HOLDOVER

Revised

HUNTER'S PARK SUBDIVISION, UNIT IV

APPLICATION NUMBER Holdover DATE February 2, 2006

HUNTERS PARK SUBDIVISION, UNIT IV

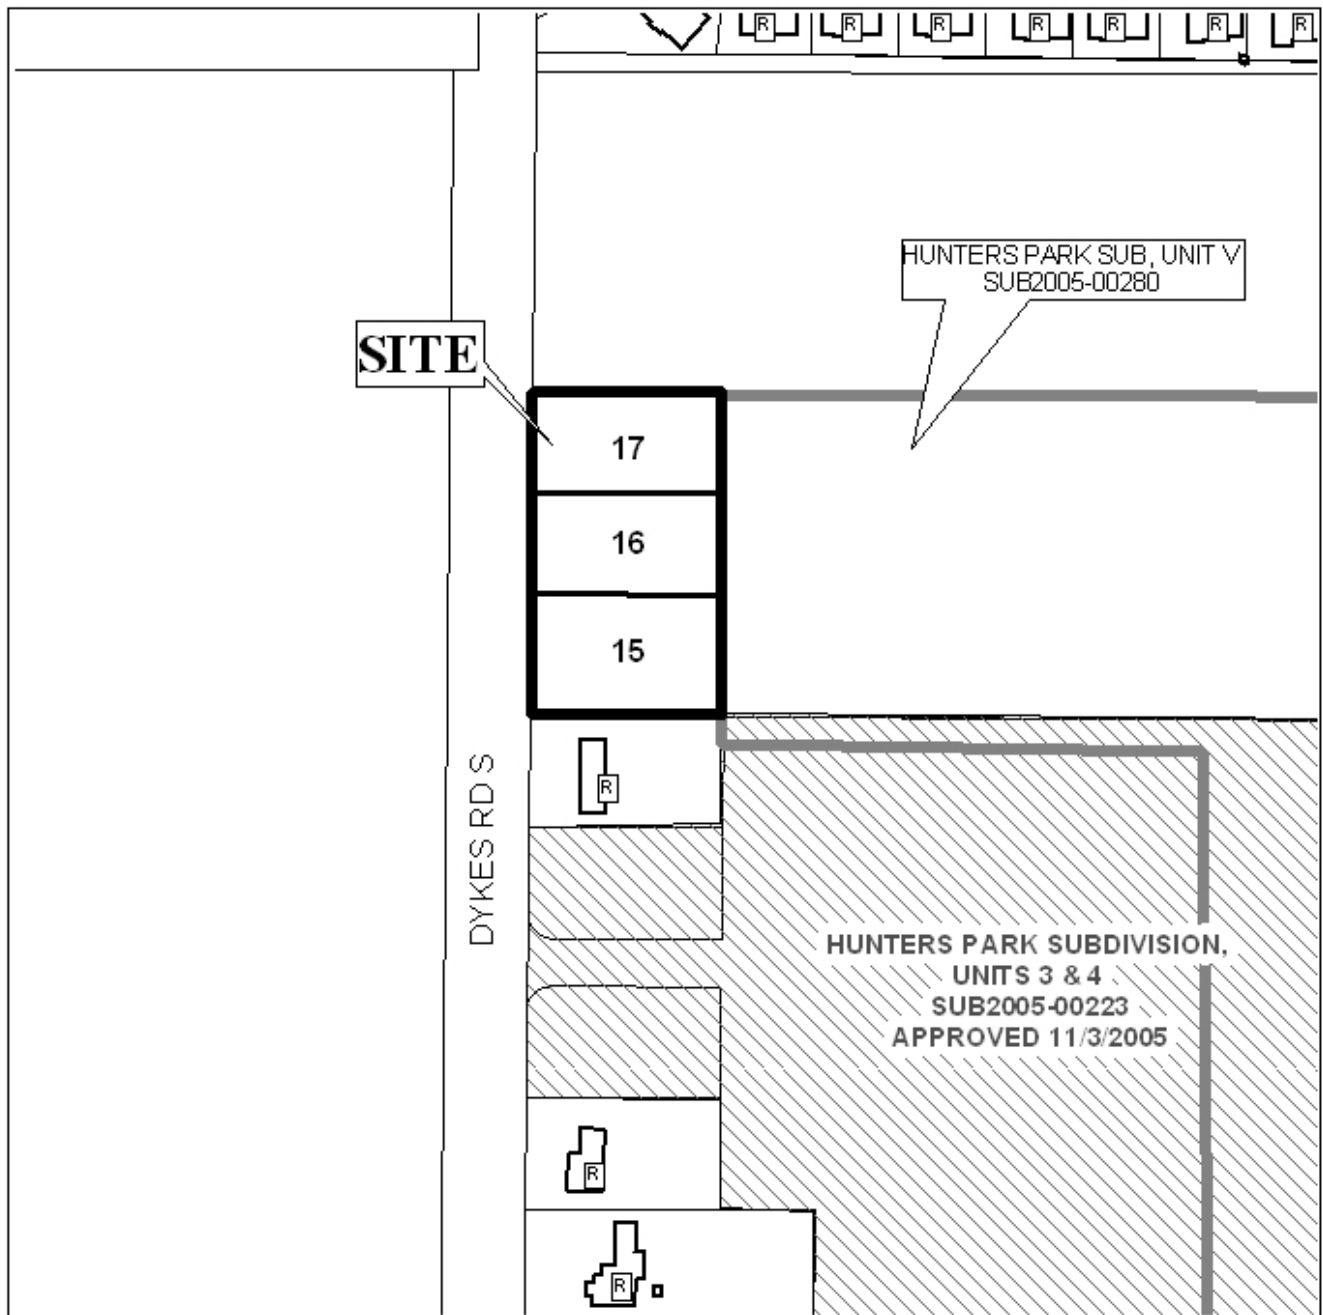
Unit IV would prevent the proposed East-West street in Unit V from connecting to Dykes Road South, which is an undesirable outcome for the site. Minor street connections benefit neighborhoods by allowing dispersion of traffic, more access points for emergency vehicles, and more efficient distribution of roads and utilities; this site presents unusually good opportunities to increase the connectivity of existing and proposed neighborhoods.

The Unit V plat illustrates a stub North connecting to Summerlake and one West to Unit III. By extending the proposed East-West cul-de-sac to Dykes Road South through the subject property, traffic would be alleviated for adjoining streets in Hunter's Park and Summerlake, and the neighborhood would become more accessible by emergency vehicles.

This application was held over from the January 19th meeting, to allow the applicant to submit revised materials coordinating Units IV and V, to increase the connectivity of the streets. The applicant's engineer has not submitted any additional materials, but has noted that a portion of the previous report was in error; the site does not in fact adjoin Summerlake subdivision. Nevertheless, the provision of a street connection through Unit IV, rather than terminating the new road in a cul-de-sac, is strongly recommended by Urban Development. As this would impact

the proposed lots, they should be configured to ensure that they maintain the minimum lot size required for a site served by public water and sanitary sewer (7200 square feet).

The site otherwise meets the minimum requirements of the Subdivision Regulations. Based on the preceding, this application is recommended for Tentative Approval, subject to the following conditions: 1) revision of the plat to show a street connection between Dykes Road South and the new street in Hunter's Park Unit V; 2) reconfiguration of the lots to ensure that minimum lot size (7200 square feet where served by public water and sanitary sewer) is maintained; 3) construction and dedication of the new street to County Engineering standards; and 4) the placement of a note on the final plat stating that any lots that are developed commercially and adjoin residentially developed property must provide a buffer, in compliance with Section V.A.7 of the Subdivision Regulations.
